POTENTIALLY UNQUALIFIED COMPONENT IN CERTAIN ALLEN BRADLEY TIMING RELAYS

UPDATE - Report of potential 10CFR Part 21, Allen Bradley Timing
Relay Model 700RTC
Report No: P21-04302015, Rev. 1

Part 21 Report No: P21-04302015, Rev. 1

Figure 2 - New design circuit board and CPLD that replaced the original component.

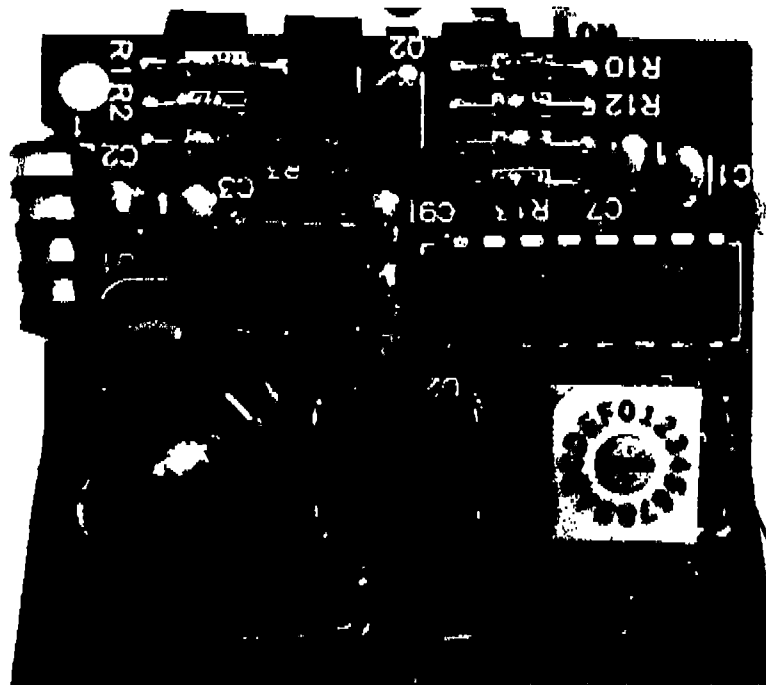
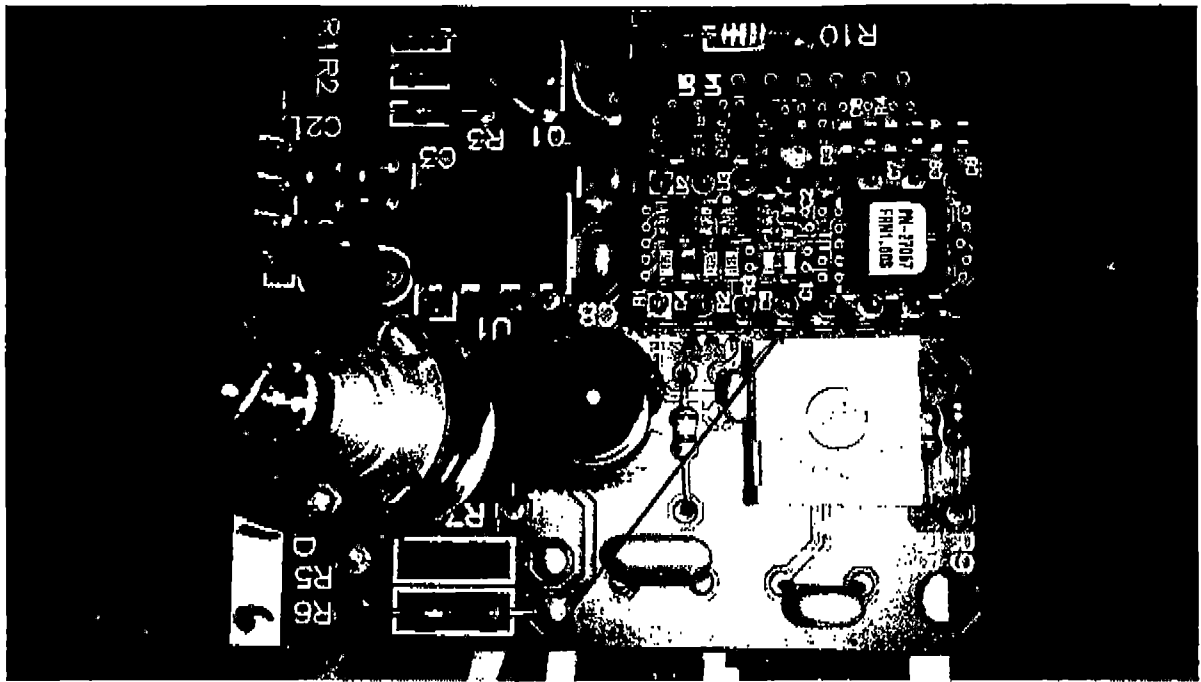
Between 2009-2010, Allen Bradley made a design change without changing the part number of the commercial relay or providing any documented evidence of a design change. The manufacturer specification data sheets maintain the classification that the relays are "solid state", which would imply that there are no digital devices installed in the relay. However, after inspection of the internals of the timing relay (Figure 2), it has been identified that the unit does contain a CPLD which meets the definition of a digital device under the guidance of NEI 01-01. See Figures 1 and 2 below:

Figure 1- Original qualified design (prior to 2009).
Relays supplied prior to 2009 are not affected by this issue.

The relays that are currently in stock at NLI have been placed on hold until after the units have been determined to be qualified for the specific application. NLI has completed the EMC qualification testing per the requirements of EPRI TR-102323 Rev. 3 for the following tests, as applicable: CE101, CE102, RE101, RE102, RS101, RS103, CS101, CS114, CS115 and CS116.

The results were satisfactory with exception of the following condition: During Conducted Susceptibility CS114 onto the power lines, with the timing circuit in operation, the timing contacts exhibited chatter in the range of 2.6 MHz to 20.3 MHz. The unit requires a ferrite to be installed onto the input power lines of the relay with 3 turns through the ferrite core. In this modified configuration, the relay was not susceptible to Conducted Susceptibility and successfully passed the required test per CS114.

The relays are dedicated for generic application usage in timing applications. The specific plant application(s) is unknown by NLI. The EMC qualification of the relay is dependent on the installed configuration and location in the plant. The plant should evaluate whether the installed relays are subjected to the specific EMI/RFI condition Conducted Susceptibility CS114 between the frequencies of 2.6 MHz to 20.3 MHz identified above.
